## **Visual Inspection of VPTs**

B W Kennedy  
Rutherford Appleton Laboratory  
24 January 2002

**Figure 3. Example of ideal crimping of pins to leads**

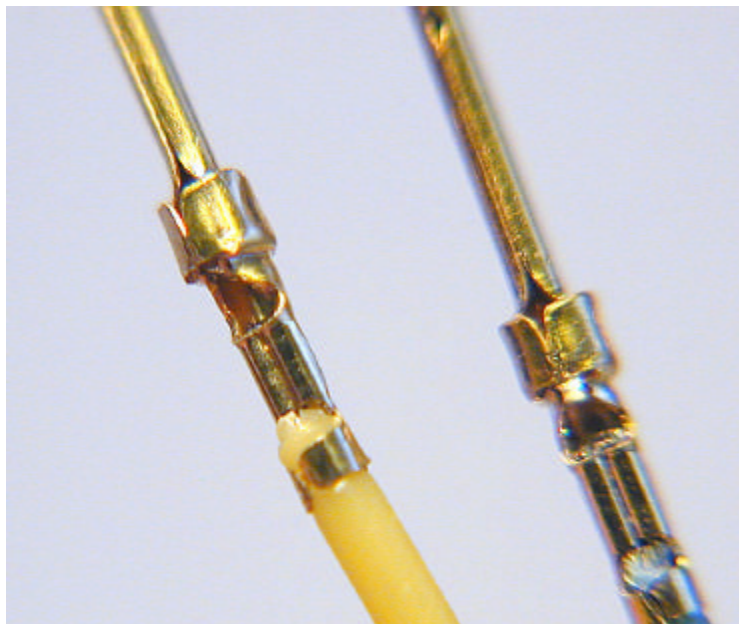
Some examples of poor crimping are shown in Figure 1 and Figure 2. Figure 3 shows the ideal method of attaching the pins.
